# STATE OF OHIO DEPARTMENT OF TRANSPORTATION

## GRE-68-12.65

XENIA TOWNSHIP

GREENE COUNTY

RESIDENTIAL DRIVEWAY PROFILES  
 6' or Greater Buffer

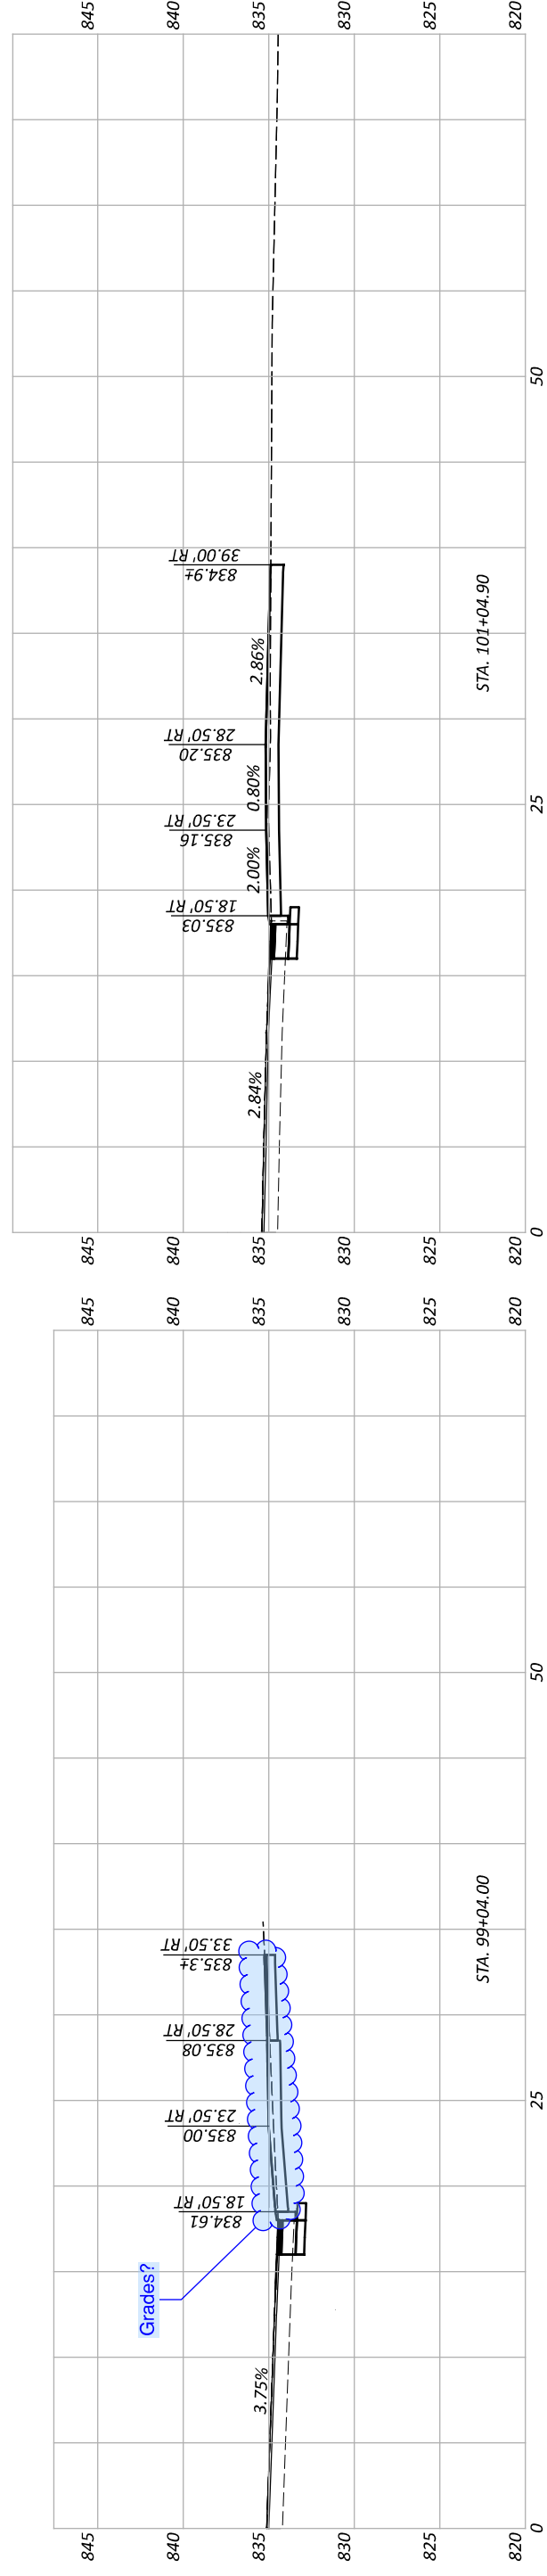
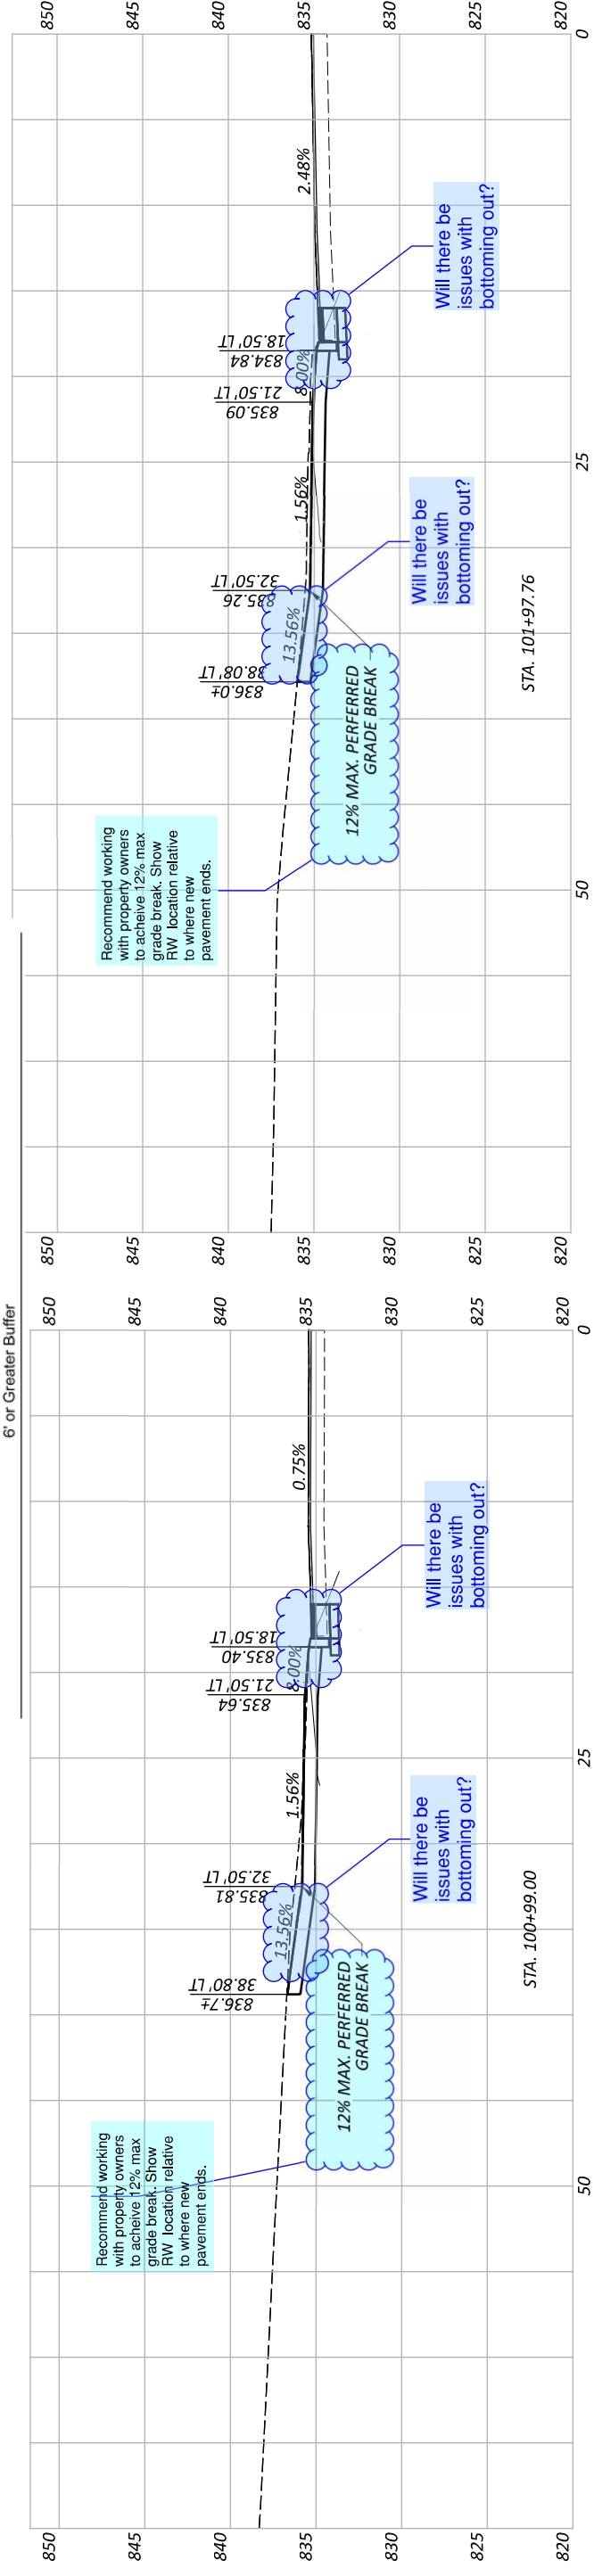
Grades?

RAMP RETAINING WALL PLAN  
 BRIDGE NO. GRE-BK8020-00.492  
 PEDESTRIAN BRIDGE OVER US 68 AND OLD TOWN CREEK

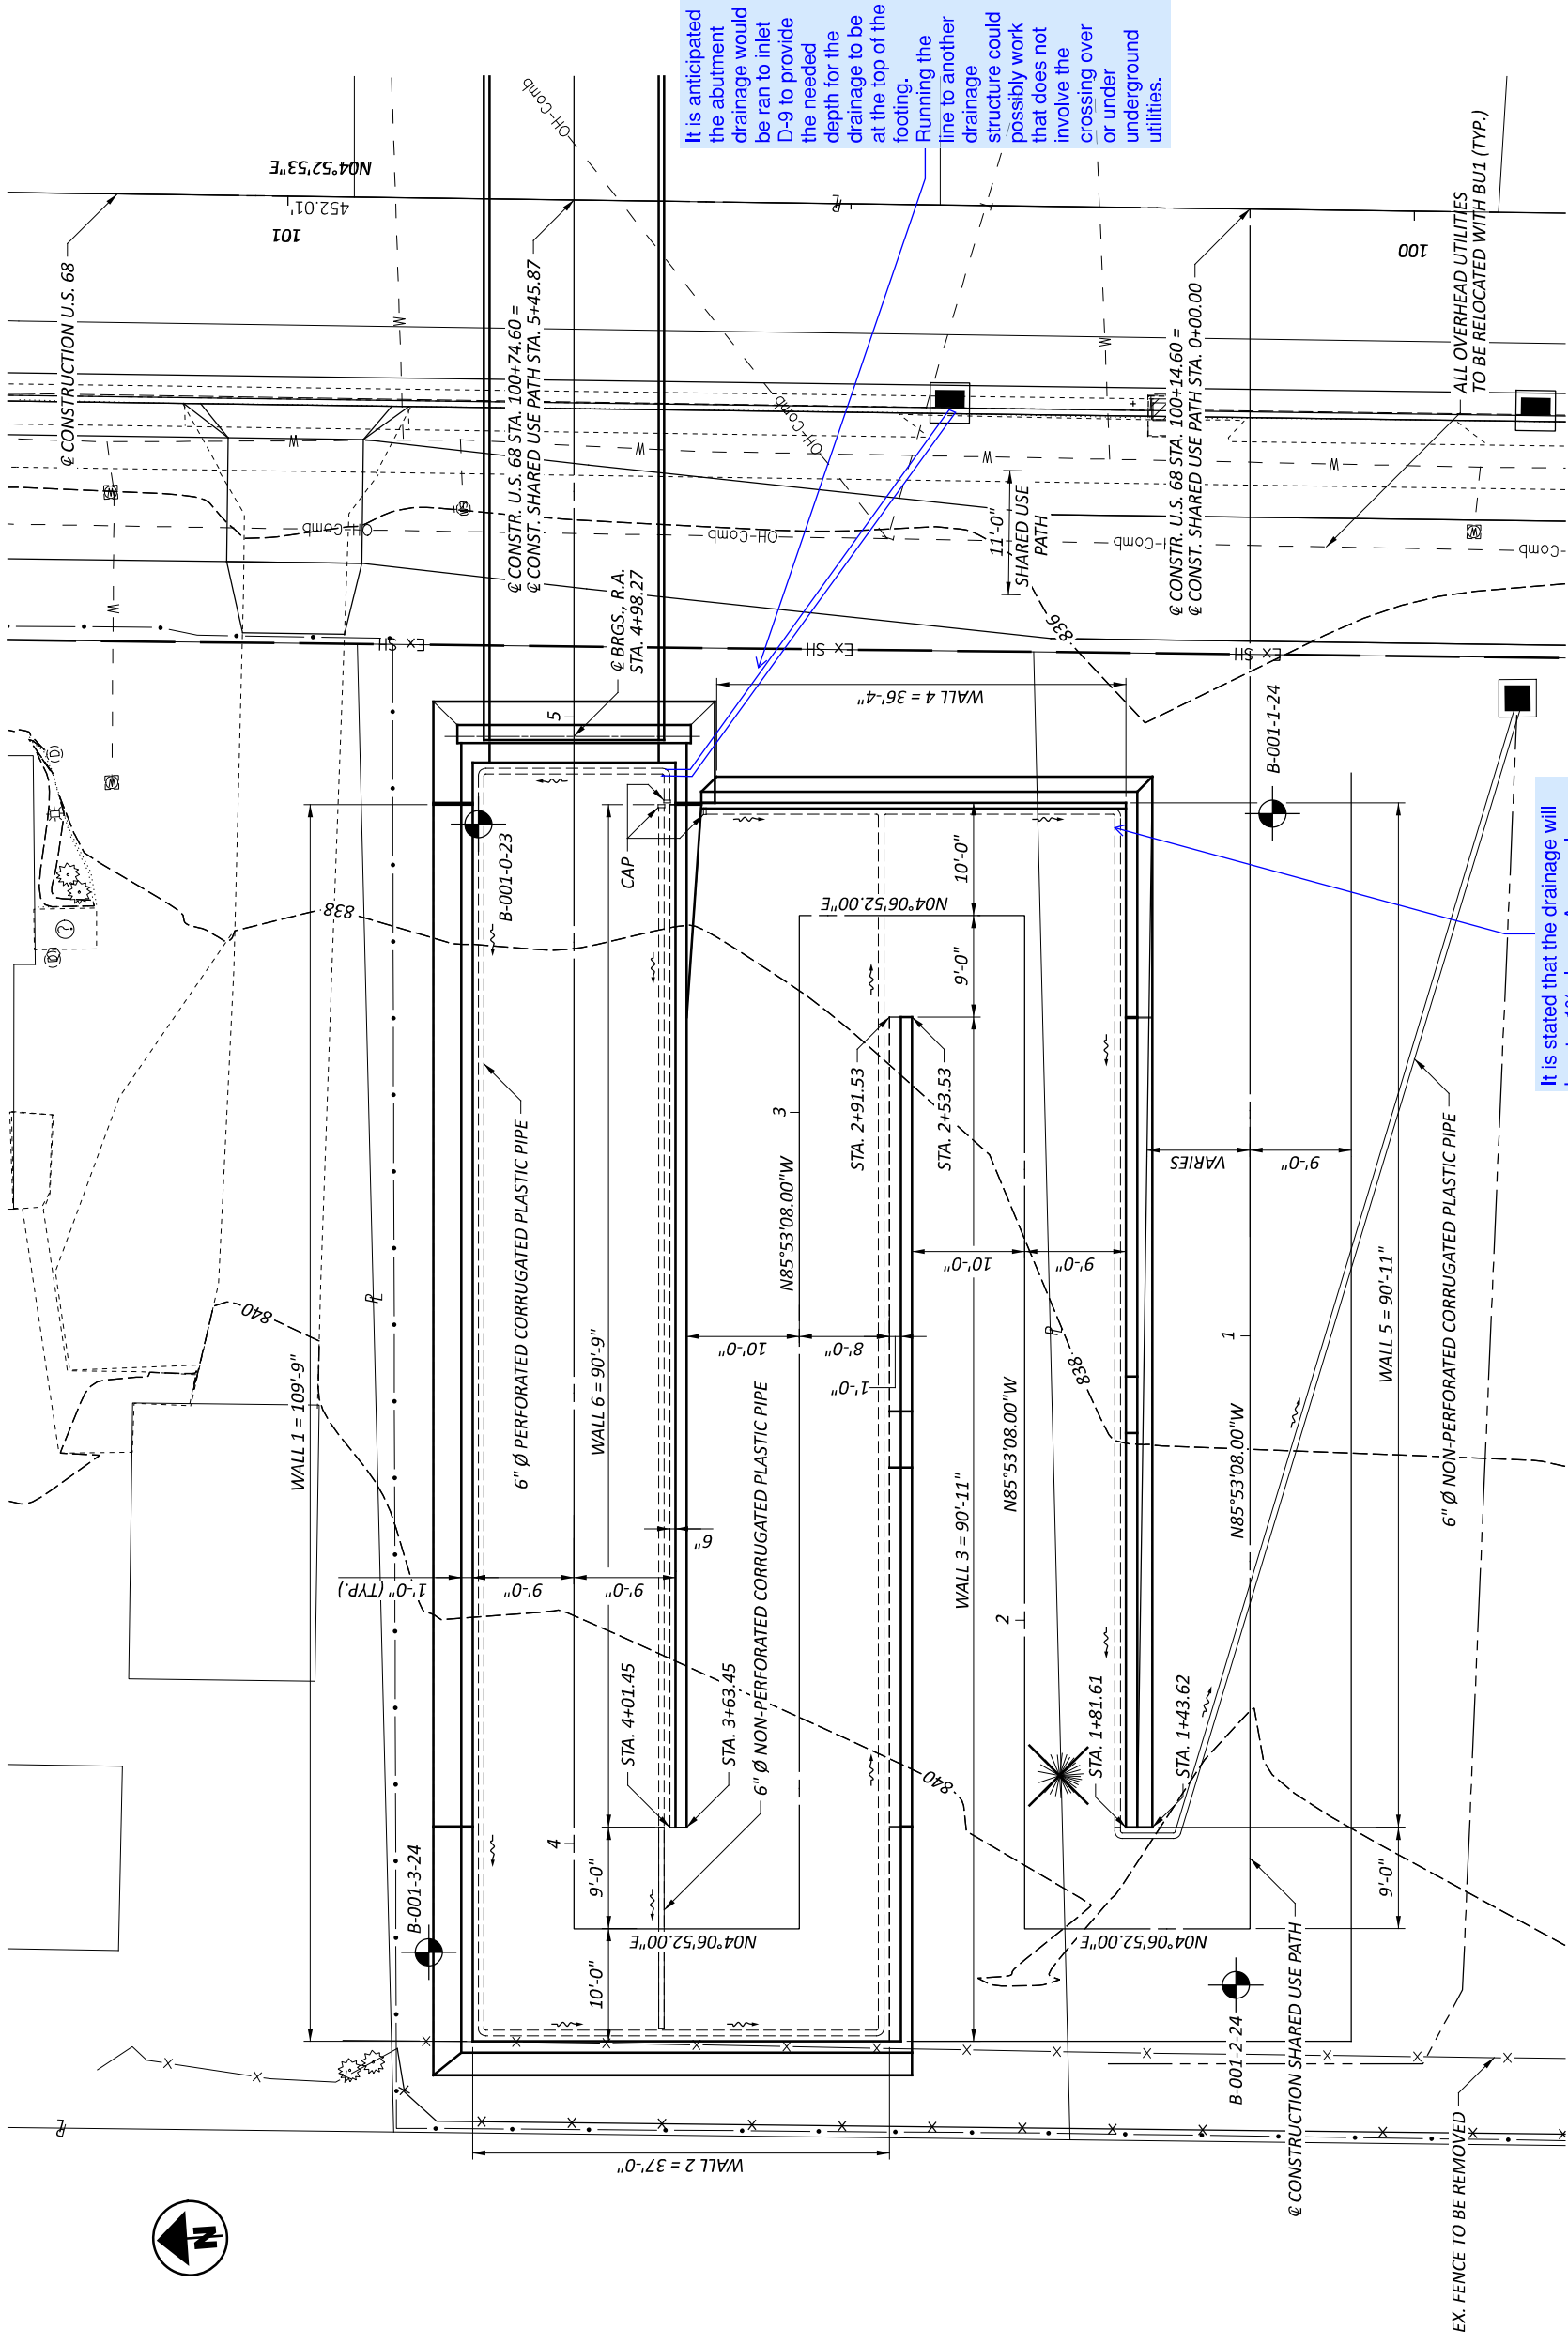
It is stated that the drainage will be at a 1% slope. As complex as this drainage system is, it seems that pipe elevations at the corners would aid in these being set close to their correct elevations.

It is anticipated the abutment drainage would be ran to inlet D-9 to provide the needed depth for the drainage to be at the top of the footing. Running the line to another drainage structure could possibly work that does not involve the crossing over or under underground utilities.

BRIDGE NO. GRE-BK8020-00.492  
 PEDESTRIAN BRIDGE OVER US 68 AND OLD TOWN CREEK  
 WALL 1 DETAILS

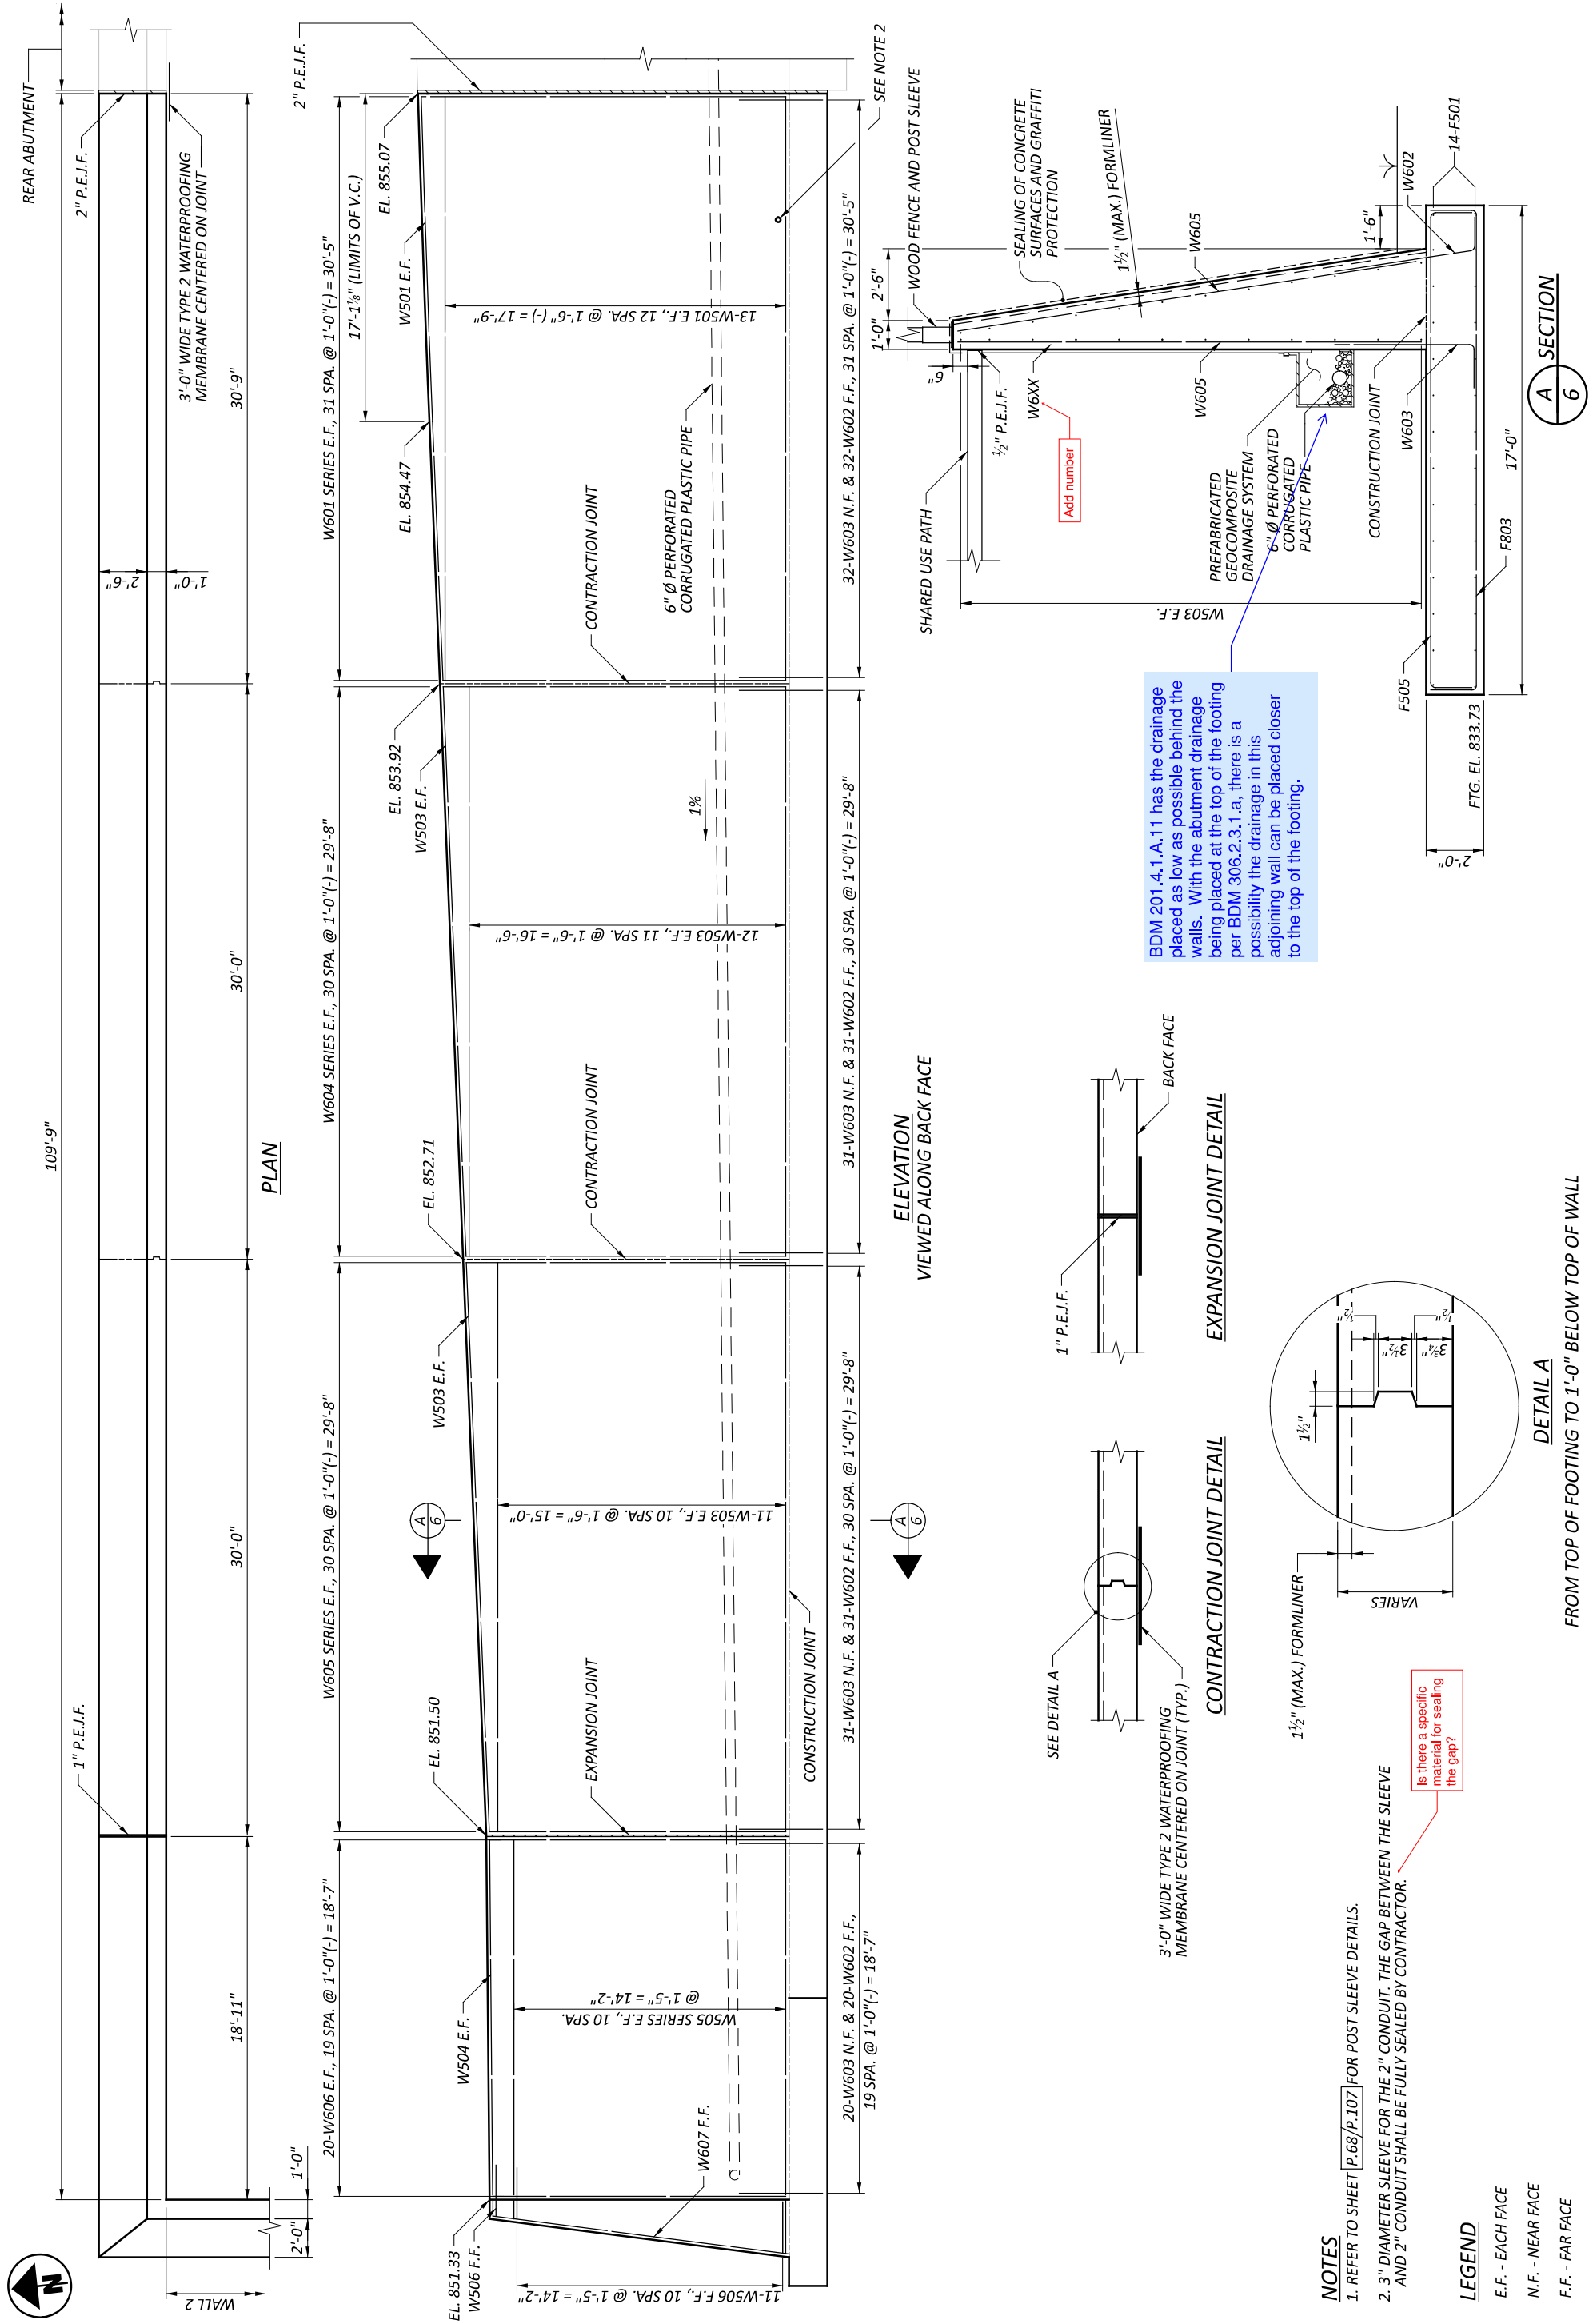
BDM 201.4.1.A.11 has the drainage placed as low as possible behind the walls. With the abutment drainage being placed at the top of the footing per BDM 306.2.3.1.a, there is a possibility the drainage in this adjoining wall can be placed closer to the top of the footing.
